FILE NUMBER: PLN23-075

SUBJECT: Design Review, Grading Approval, and Special Permit

SITE LOCATION: 19471 Mountain Way, Los Gatos, CA 95030 (APN: 510-53-022)

Fig. 4.20-1
Accessory Building Height

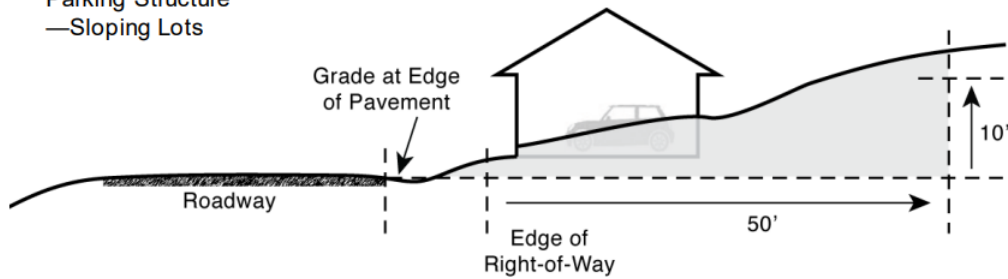
9. On sheet A2.3, please label the final exterior grade, and provide the height for the proposed detached garage using roof-averaging height measurement. Pursuant to County Zoning Ordinance, the height shall be measured from the final exterior grade to the average vertical dimension between the ridge and top plate of the wall (see Fig 4.20-1).

Check the latest garage shrink small.
